SAFETY RECALL BULLETIN

NHTSA RECALL 25V679

AUTOCAR, LLC ACX-2505 DC-2507

Autocar, LLC has decided that a defect which relates to motor vehicle safety exists in certain, 2024–2026 model year Xpeditor (ACX) and Legend (DC) chassis. The tie rod end clamps may not be properly secured.

Figure 1

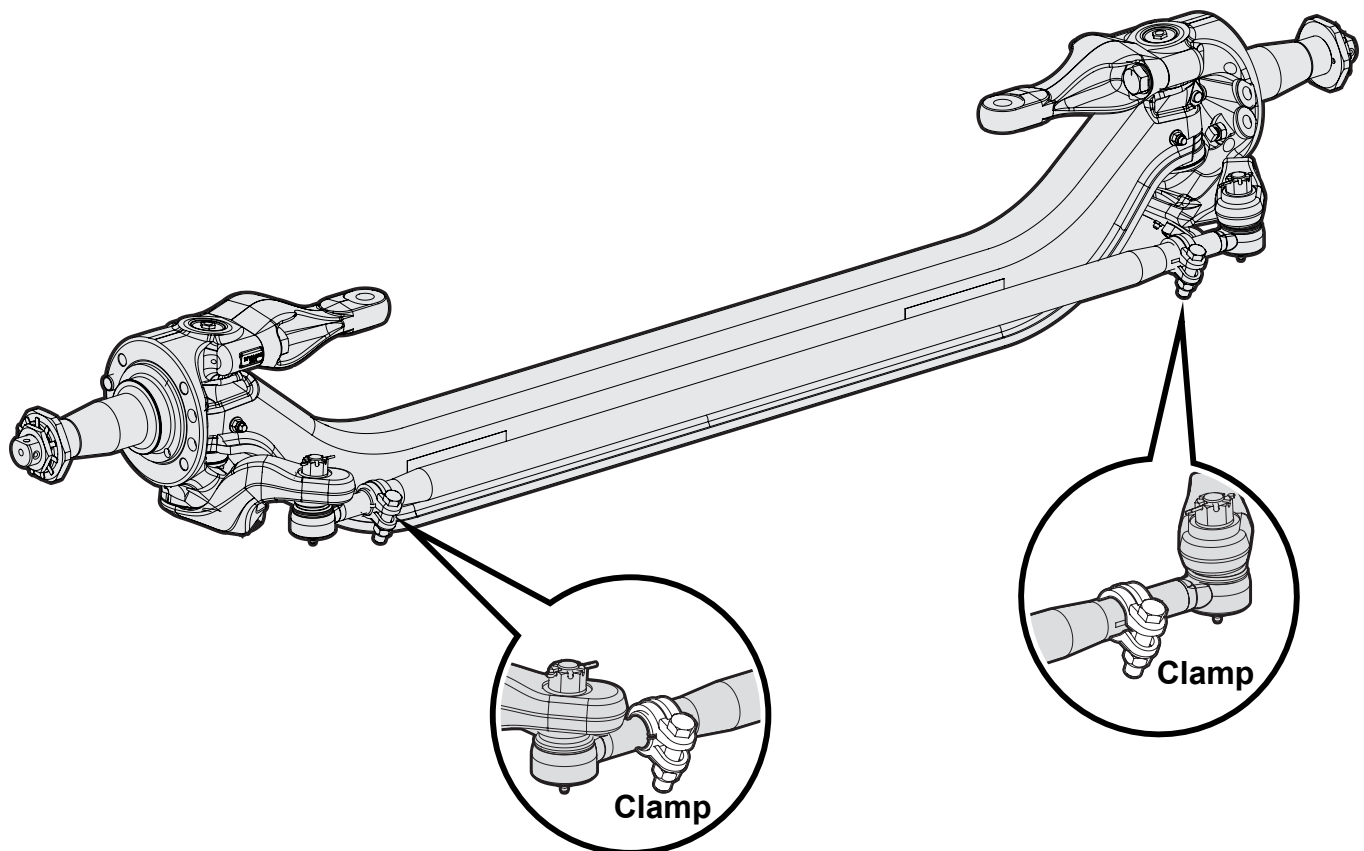
1. Follow all lockout/tagout procedures and verify the battery disconnect switch is in the “OFF” position. If the unit is not equipped with a battery disconnect switch, disconnect the battery cables beginning with the negative cables, followed by the positive cables.
2. Verify the wheels are properly chocked.
3. Locate the steering axle tie rod end clamps (see Figure 1).

Figure 2, Correct Orientation

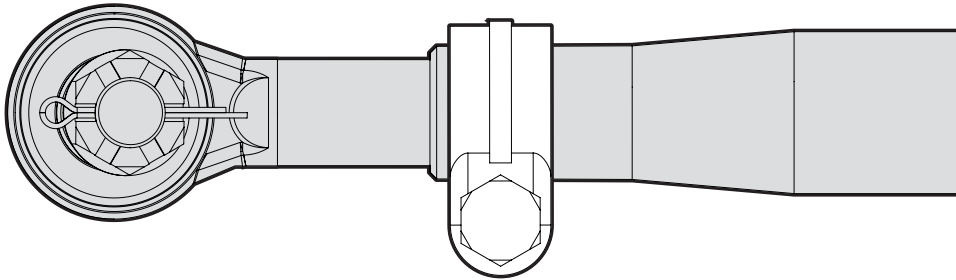
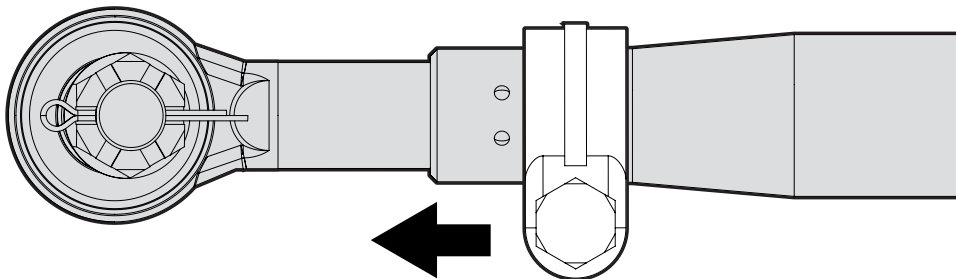
4. Verify the tie rod end clamp orientation (see Figures 2, 3, 4 and 5).

Seated Incorrectly, Move Clamp Forward For Correct Alignment

Figure 3, Incorrect Orientation

5. Adjust the tie rod end clamp orientation as required and tighten the tie rod end clamps to 70 Lbs.-Ft. of torque for 5/8" bolts or 170 Lbs.-Ft. of torque for 3/4" bolts.
6. Reconnect all battery terminals beginning with the positive connections then the negative connections.
7. Turn on the battery disconnect switch to the "ON" position.
8. Repairs are complete.

Figure 4, Correct Orientation

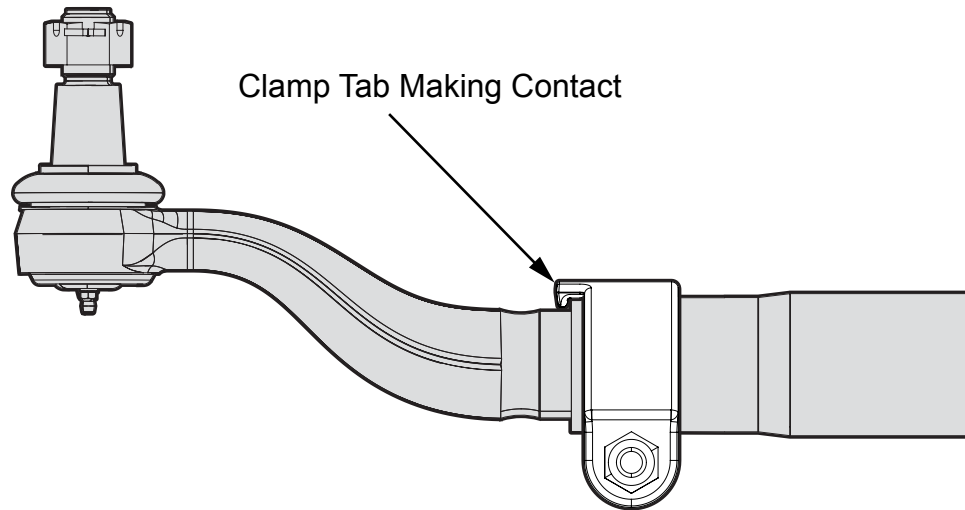
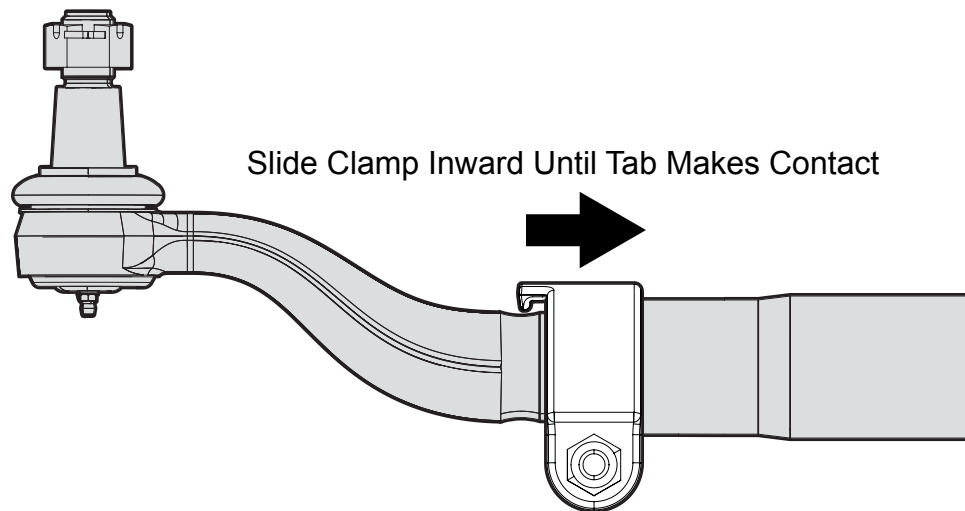
Figure 5, Incorrect Orientation
